**Summary and Analysis of Comments:  
Control of Emissions of Air Pollution  
from Locomotive Engines and Marine  
Compression Ignition Engines Less than  
30 Liters Per Cylinder**

Assessment and Standards Division  
Office of Transportation and Air Quality  
U.S. Environmental Protection Agency

**Variable-Pitch or Electronically-Coupled Engines  
(shown for engine capable of operating on E3 cycle)  
NTE Zone: Sub zones and FEL Multipliers**

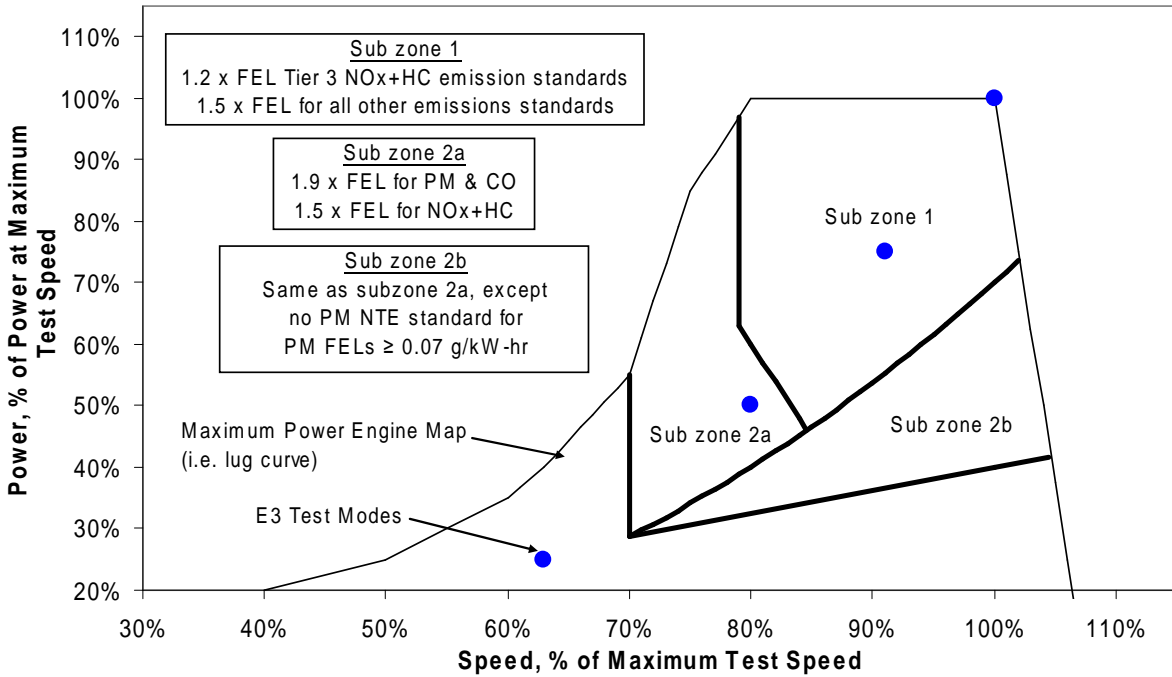
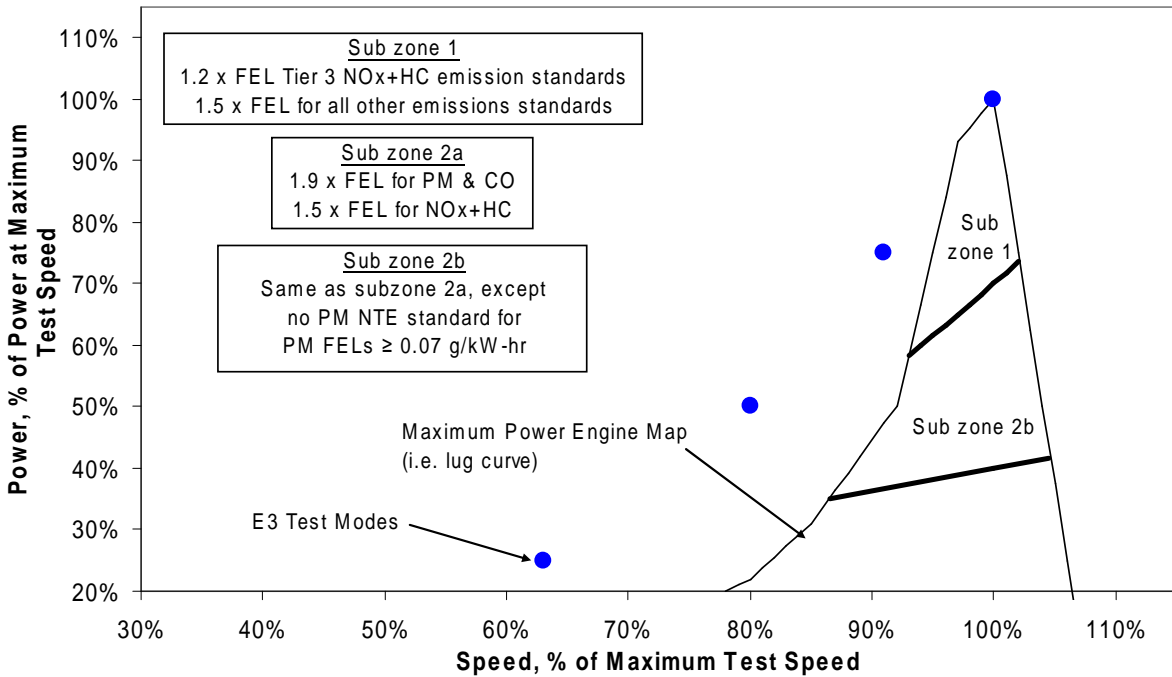
Caterpillar Inc. (Caterpillar) OAR-2003-0190-0485, 0498, 0580.1, 0591.1, 0822  
Engine Manufacturers Association (EMA) OAR-2003-0190-0575.1

After the comment period, we continued to work with the marine engine manufacturers to better understand the unique characteristics of these engines. As discussed above, applications using variable-pitch or electronically-coupled engines vary greatly. In some applications, the engine may operate similar to a fixed pitch propeller engine and others more

similar to a constant speed engine. In addition, some engines may operate over a wide range of speed and loads more similar to a nonroad engine.

Although a single NTE zone is used for all variable-pitch or electronically-coupled engines, this zone varies in appearance by power curve. For an engine capable of operating over the E3 duty cycle, it approaches the NTE zone for nonroad engines. In this case, the NTE limits are based on a comparison to the E3 duty cycle results. For engines that are not capable of operating over the E3 duty cycle, and are better reflected by the E2 duty cycle, the NTE zone and limits approach those for constant speed engines. In this case, the NTE limits are based on a comparison to the E2 duty cycle results. The following two figures present the NTE zone and limits and give an indication of how the shape of the zone is affected by the power curve of the engine.
